RE: New York SMSA Limited Partnership d/b/a Verizon Wireless Special Permit and Site Plan Application to Install a Public Utility Personal Wireless Facility at the Property Known as 52 Montrose Station Road, Town of Cortlandt, NY

Specifically, the redesigned Facility and the documents submitted herewith respond to the comments raised by the Town Engineer and Town RF Consultant as follows:

Response to the Comments from Town Engineer:

Z4 4 of 11

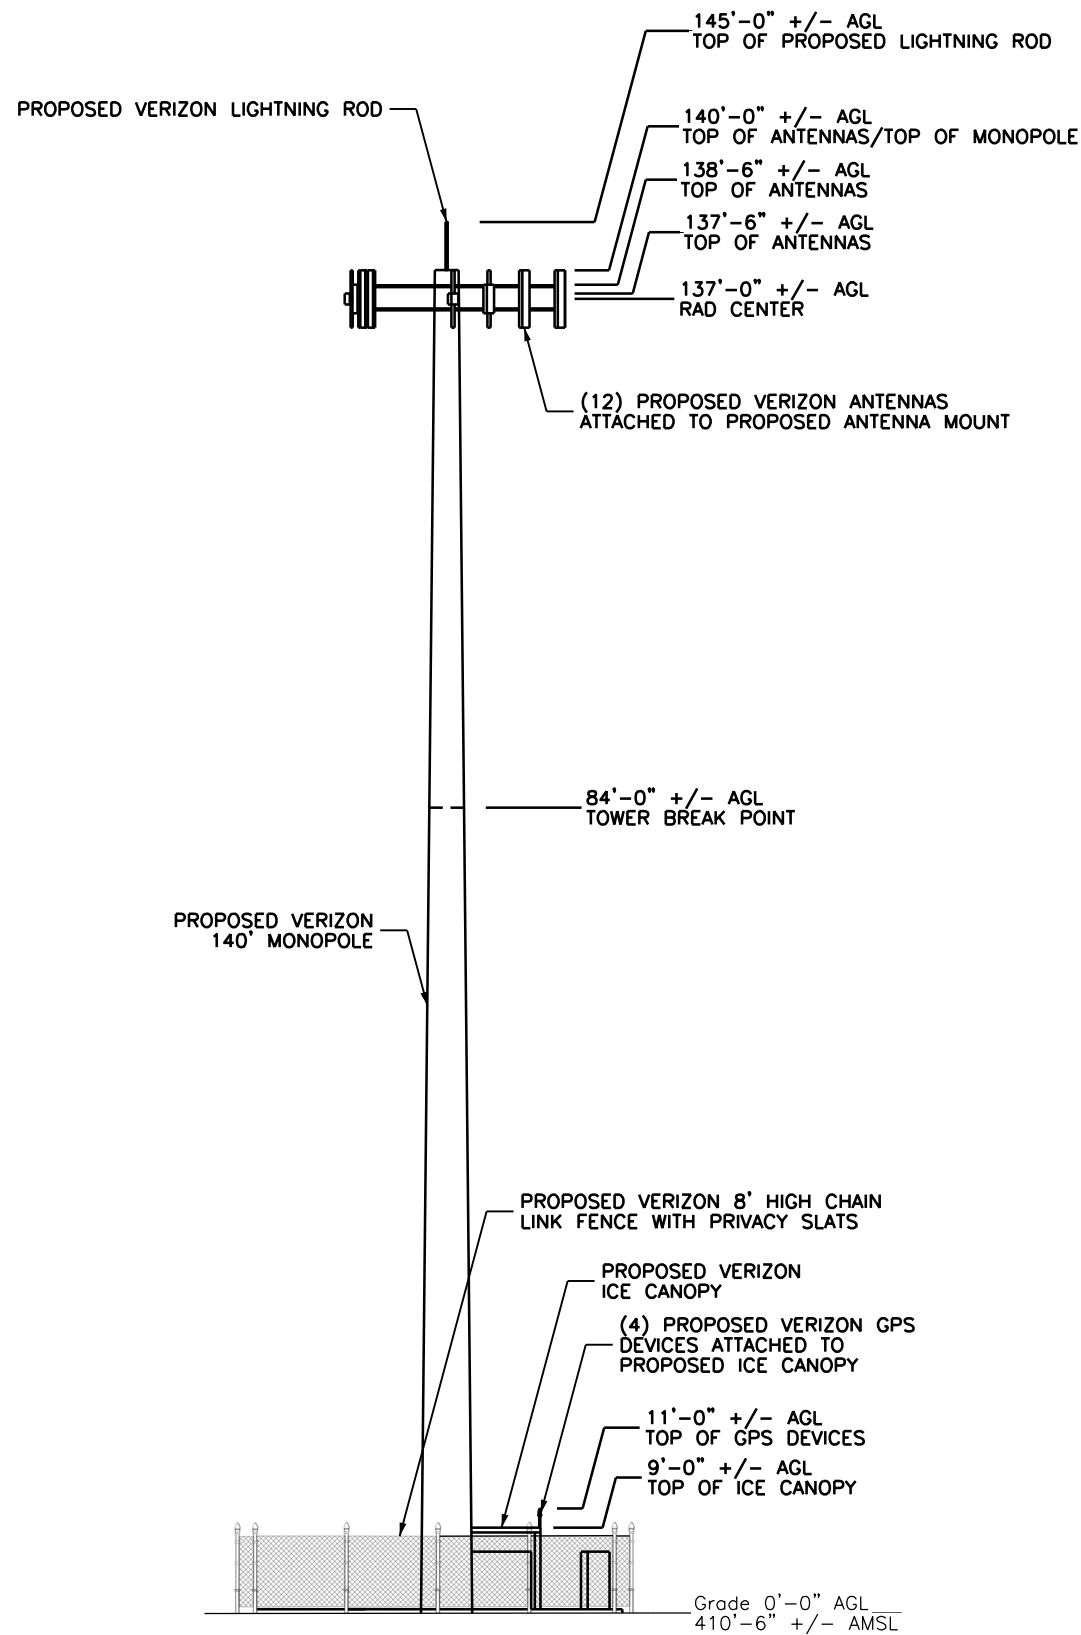
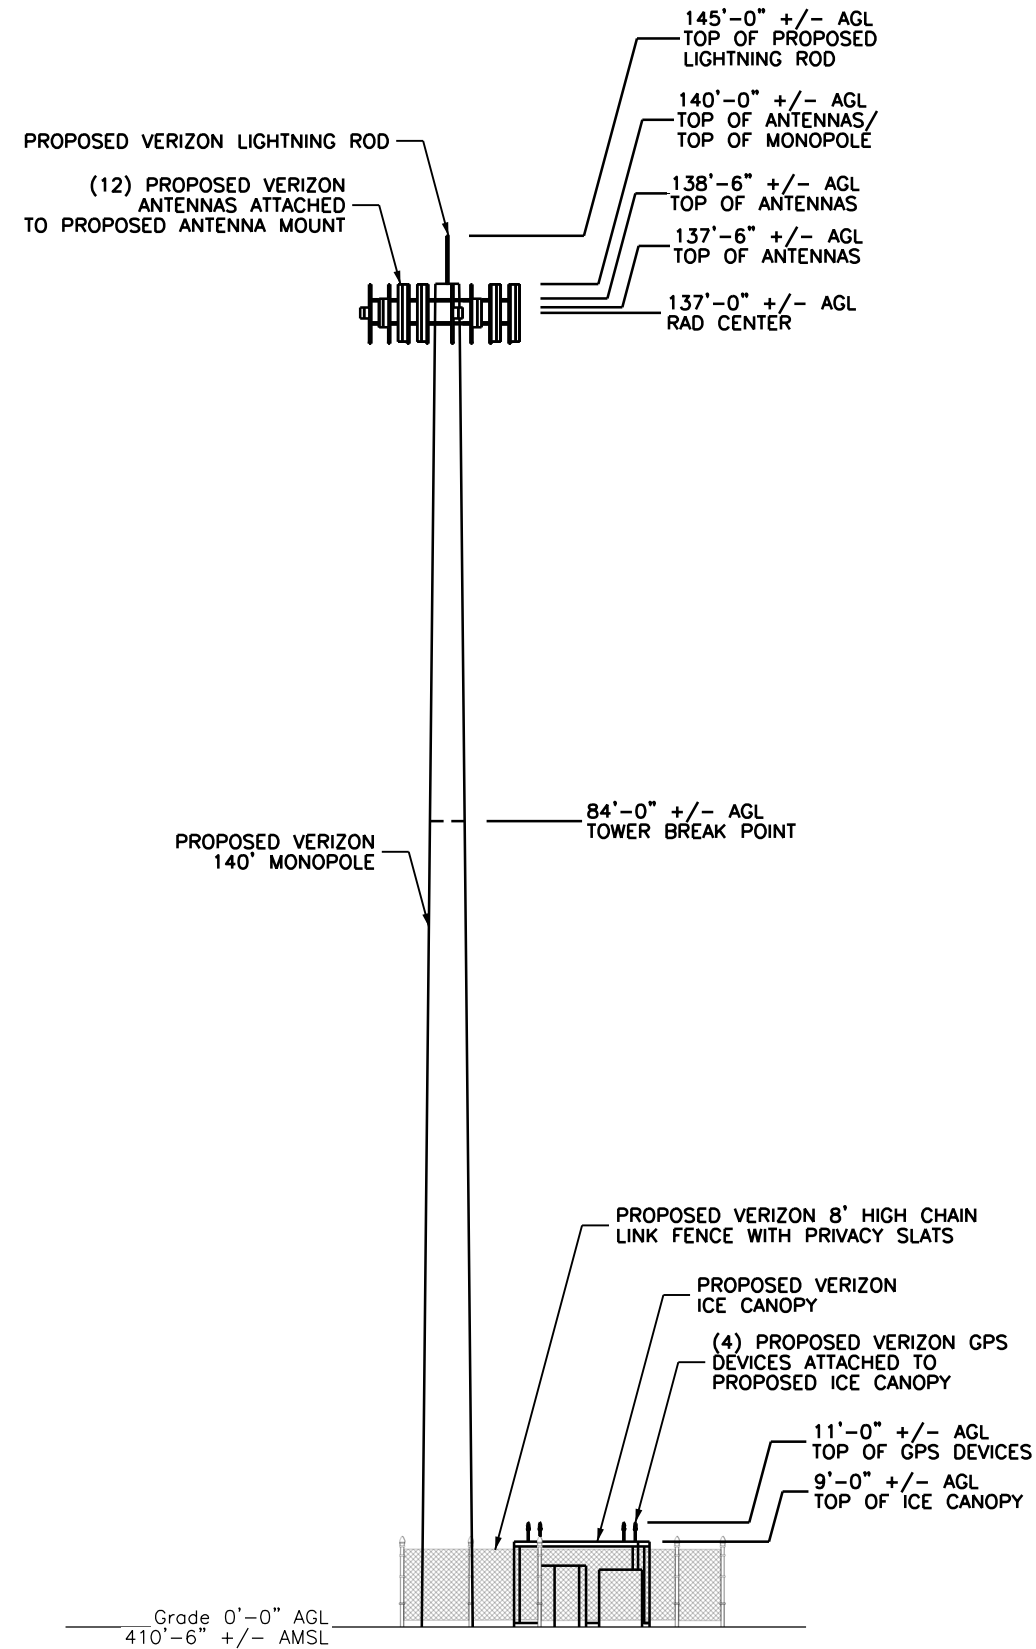
Applicant has not indicated the source of topography shown on the plans. Topography shall be field surveyed by a licensed professional land surveyor in contour intervals not to exceed 2-ft. Existing and proposed grading shall be shown

on a revised site plan. Cut and fill quantities shall be provided. Until such time as the provided the full extent of the environmental impacts cannot be evaluated.

Response: Sheet Z-10 of the Revised Plans is an existing conditions survey, which was incorporated on to the Detailed Site Plans on Sheet Z4 of the Revised Plans. Additionally, as indicated on the Updated EAF attached hereto as Exhibit 2, 100% of the proposed work will take place in areas with slopes of 0-10%. Accordingly, a steep slope permit is not required as such slopes are below 15%, which constitutes a steep slope according to Section 259-3 of the Town Code. Additionally, it is respectfully requested that the topographic and geomorphological study within the disturbance limits be a condition of the building permit, after the location of the Facility has been approved.

- Area of proposed lease agreement with the property owner. -- See Sheet Z-4 of the Revised Plans
- Re-grading (existing vs proposed) in contour intervals not to exceed 2-ft.- See Sheet Z-10 and Z-11 of the Revised Plans.

- Driveway profile with turnaround, stationed in 25-ft intervals with spot elevations provided -- See Sheet Z-11 of the Revised Plans.
- Utilities including generators and fuel storage. All utilities shall be buried. - See Sheet Z4 of the Revised Plans

DRAWING NO.: Z5 PAGE NO.: 5 of 11

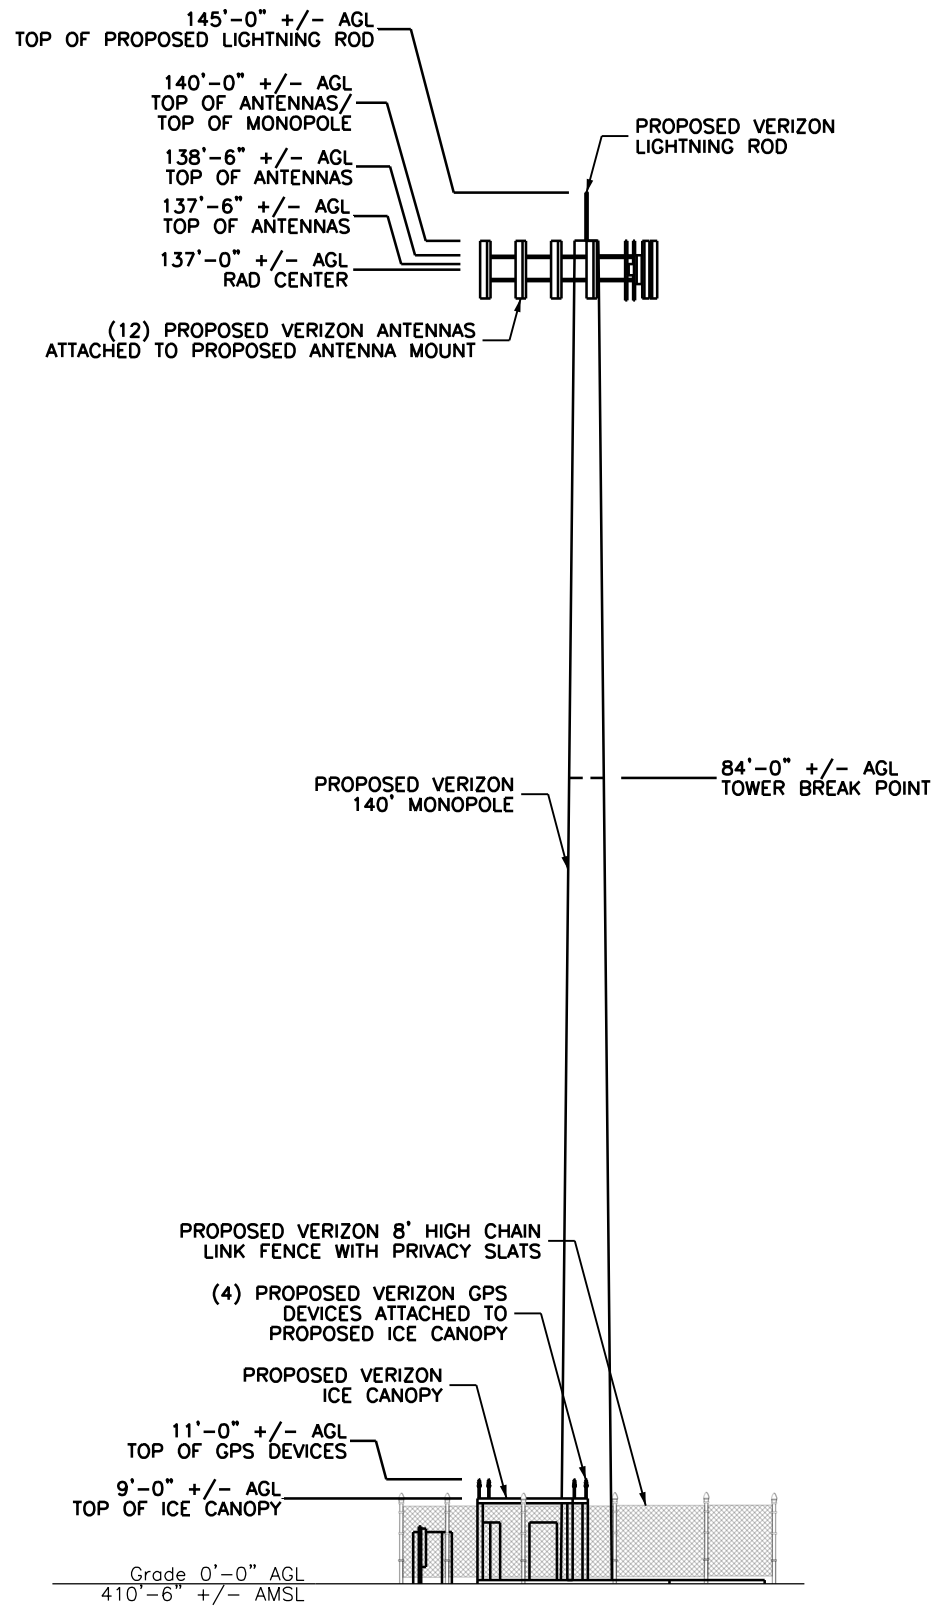
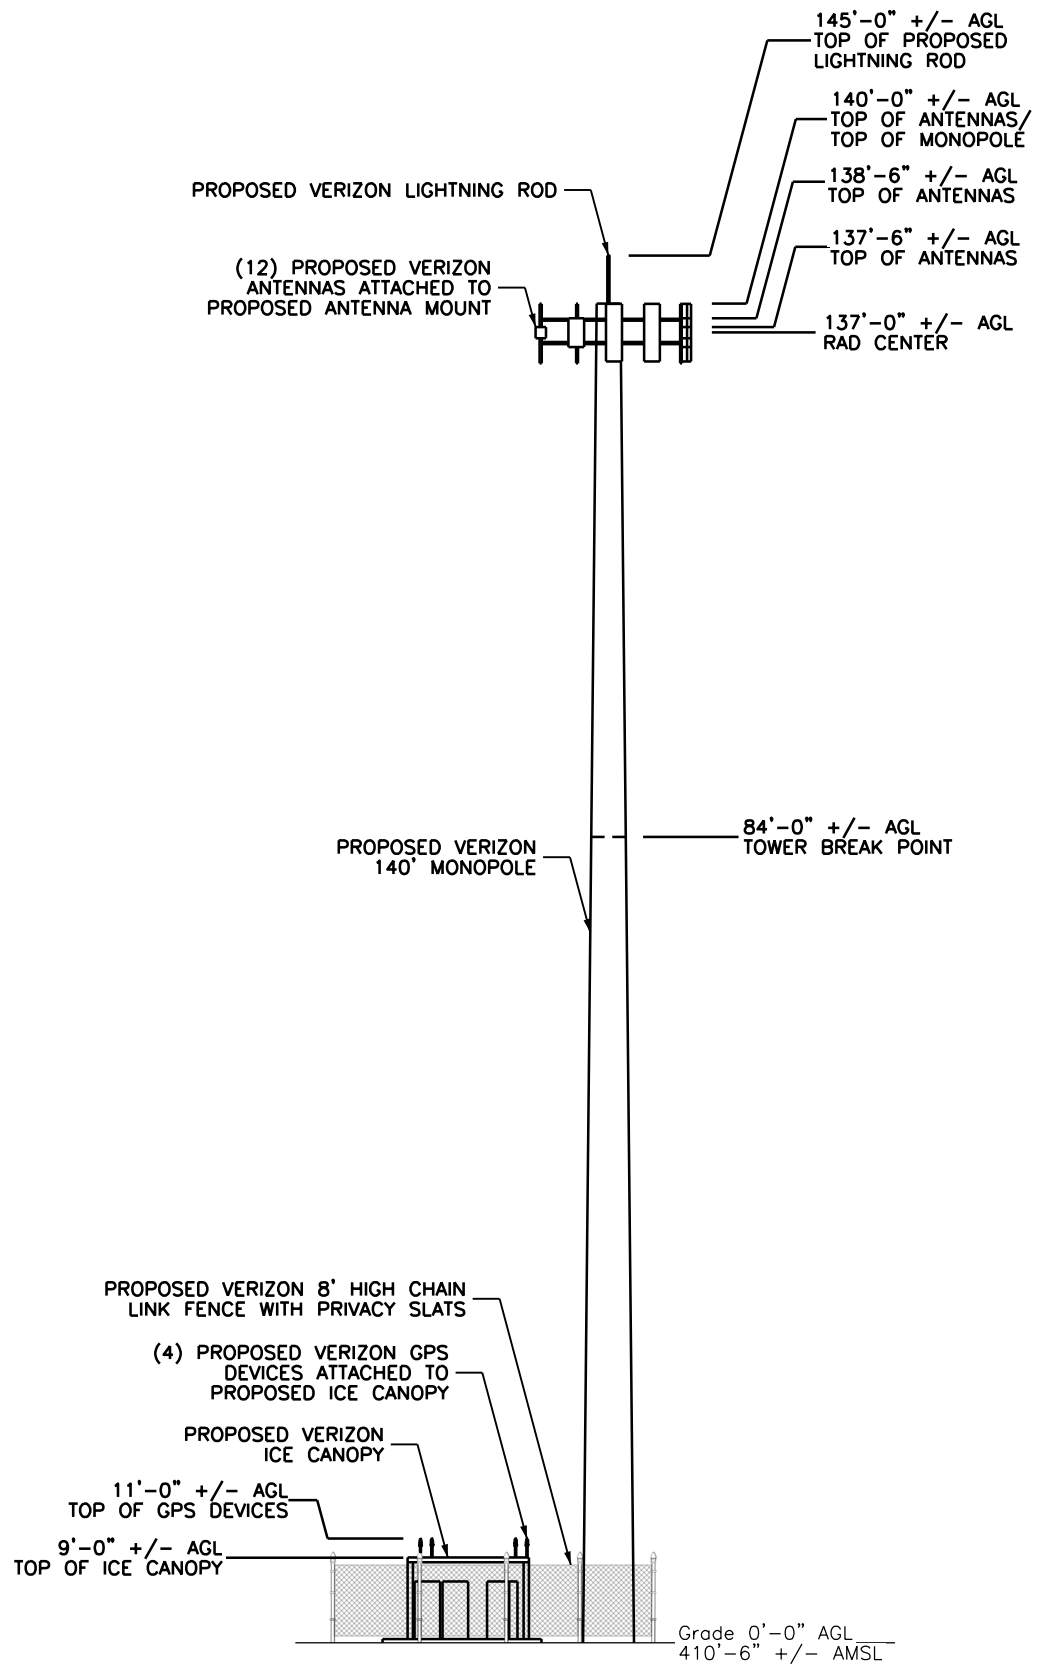
Comment #1: *The Tower is required to be setback so as to fall within the property in which it is located. The Applicant is referred to the definition of “breakpoint” as provided in Town Code Chapter 277. The Applicant shall provide a revised design showing multiple breakpoints for the proposed lattice tower or a monopole design. Furthermore, documentation of alternatives identifying additional environmental impacts, justifying the preferred location shall be provided.*

Comment #2: *The tower as designed will collapse onto adjacent property. Whether or not the property is habitable, occupied or if there is a structure is irrelevant to the breakpoint design. The applicant shall provide a map detailing the potential fall zone.*

Response: As indicated on Sheet Z-5 of the Revised Plans, the tower has a break point of 84’ AGL, such that it is designed to “fall within the property.” Additionally, as shown on Sheet Z-3 of the Revised Plans, the Facility has been relocated on the Property such that it meets the setback requirements under Chapter 277 of the Town Code.

Response: As indicated above and as shown on the Revised Plans, the tower has been relocated and designed with the break point such that the “Fall Zone” a/k/a “Collapse Zone” is entirely on the Property. See Sheet Z-3 of the Revised Plans.
